ADDENDUM #2

Project: Phase #2 of Finish Renovations at
John Wood Elementary School.
6100 East 73rd Ave
Merrillville, Indiana 46410
Architect's Project #25058

This addendum forms a part of the Bid Documents and modifies the original Bid Documents dated 1/29/2026 as noted below. Acknowledge receipt of this addendum in the space on the Bid Form. Failure to do so may subject bidder to disqualification.

SHEET
A
1.1.4

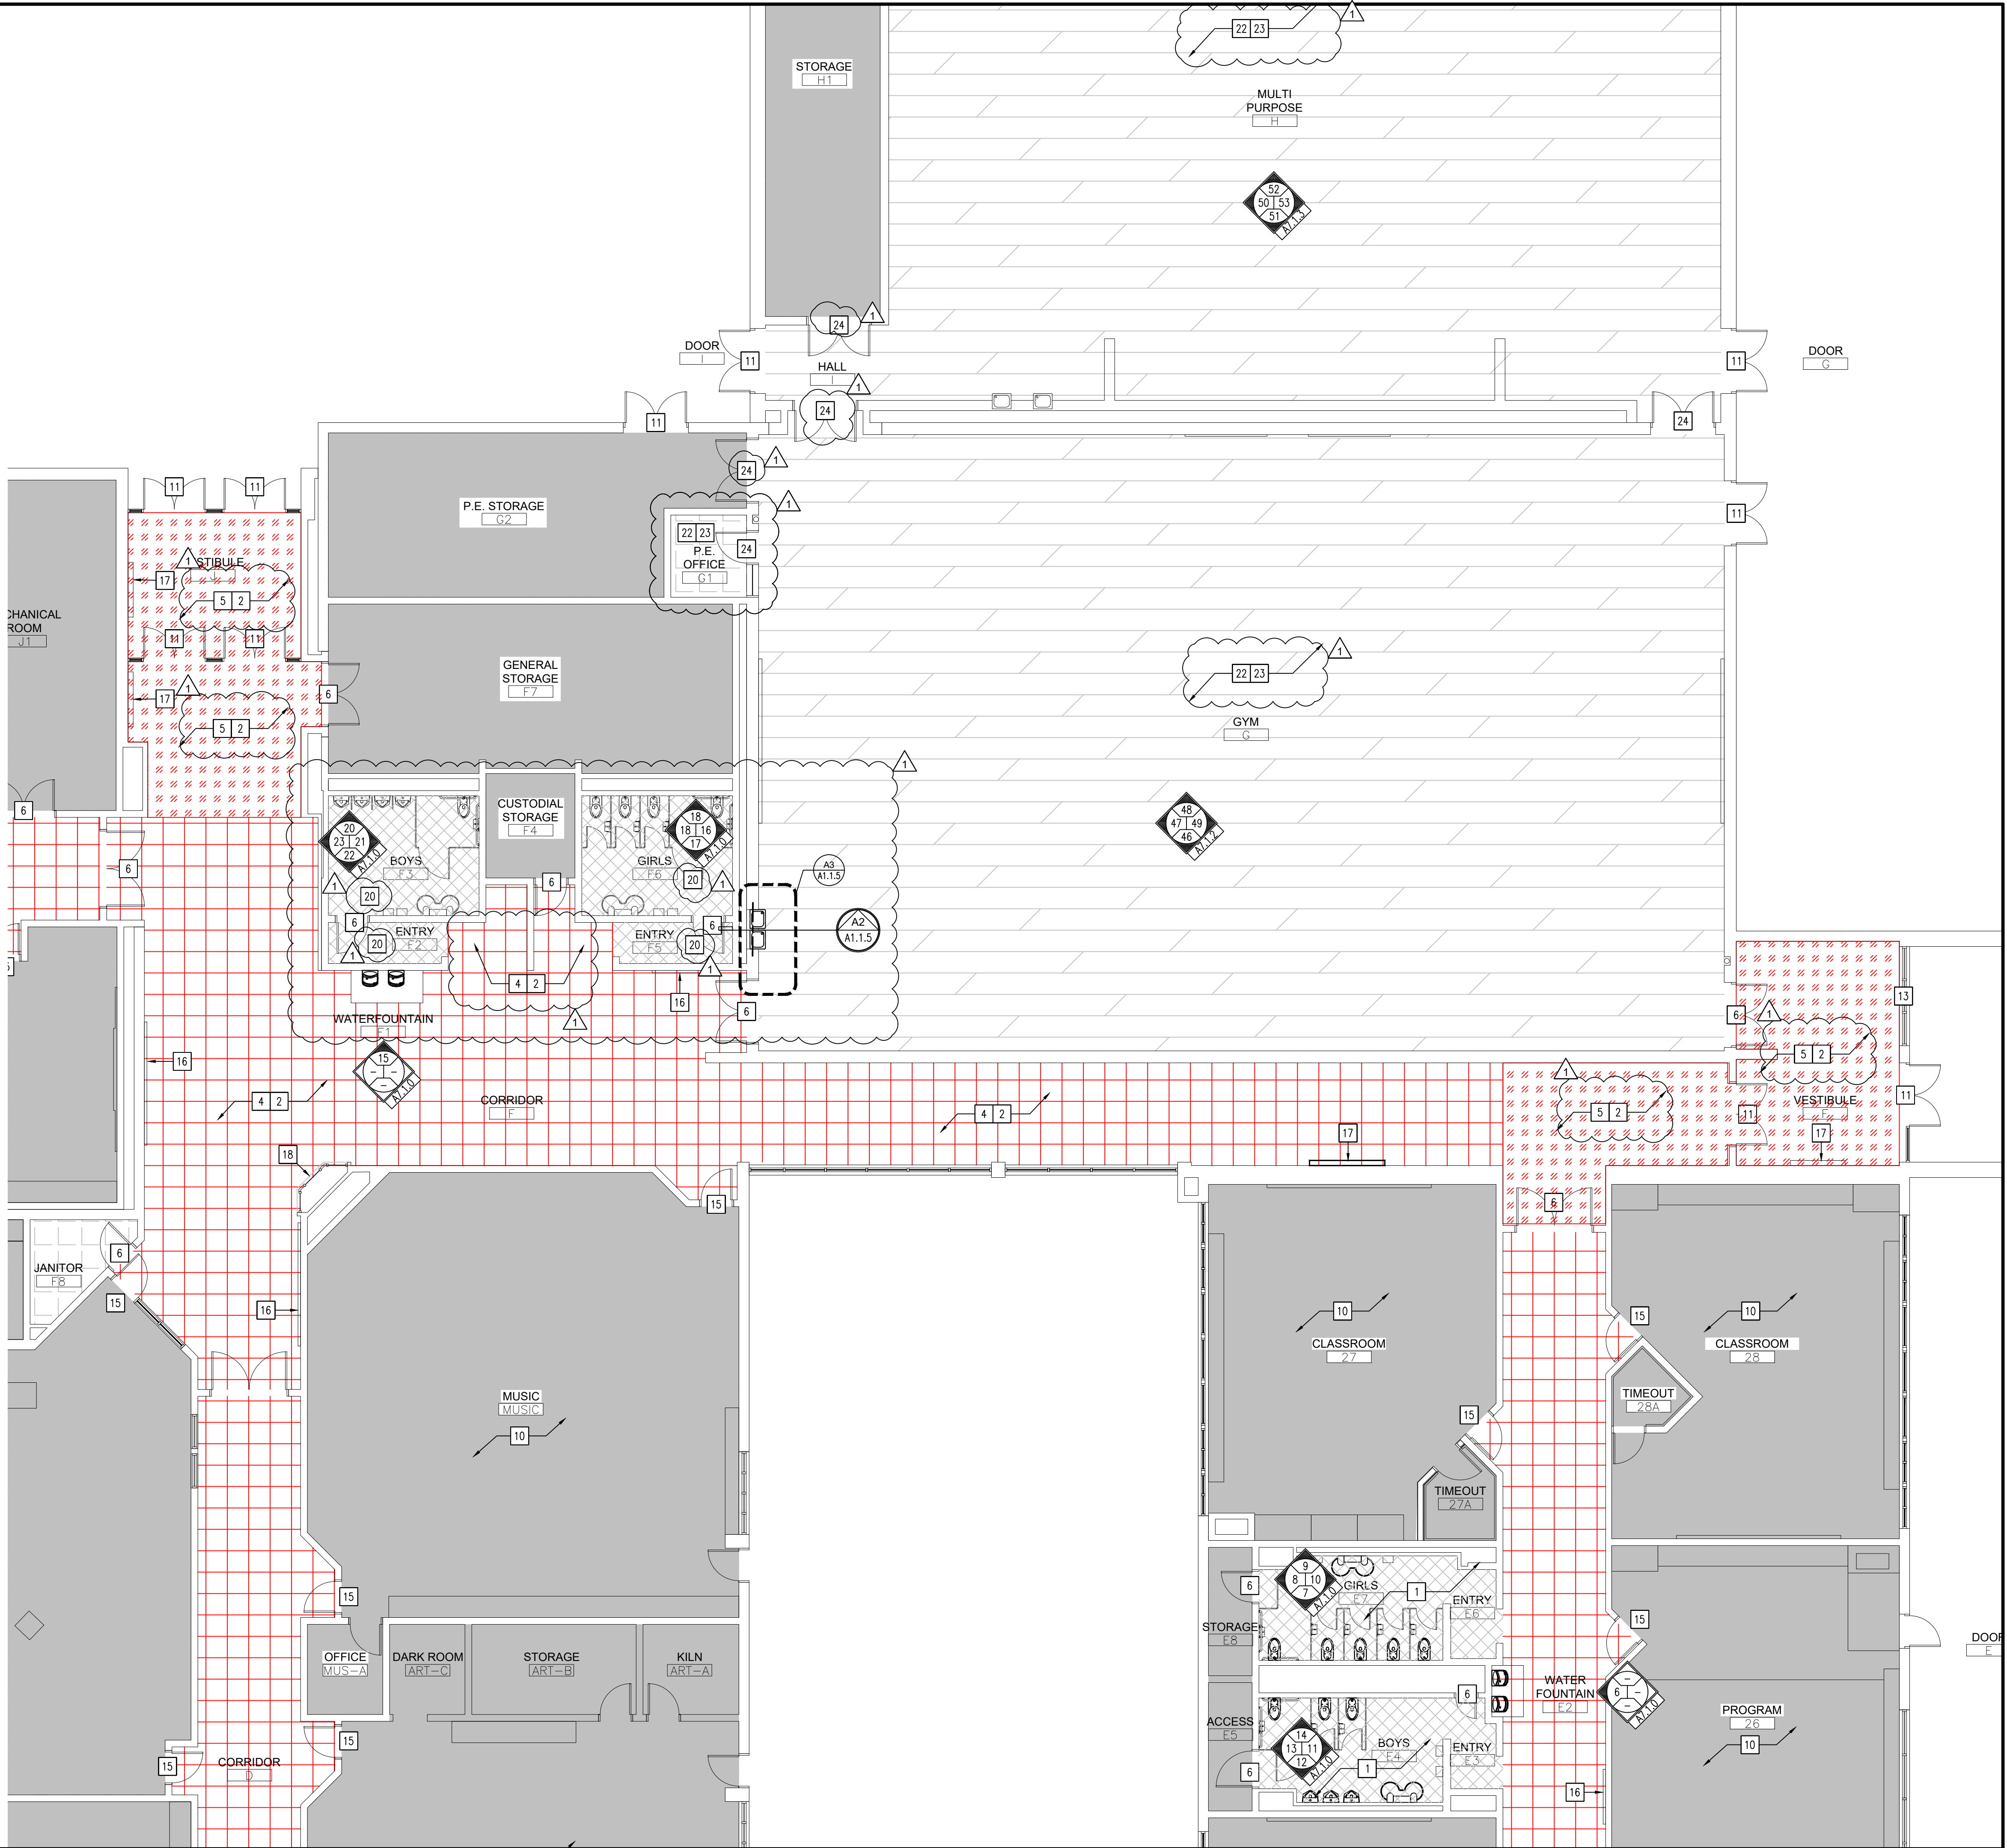
12. See attached Revised Drawing Sheet A1.1.4 – _Partial Floor Plan – Area D – New Construction - This plan shows clouded and tagged revisions dated 02-17-2026
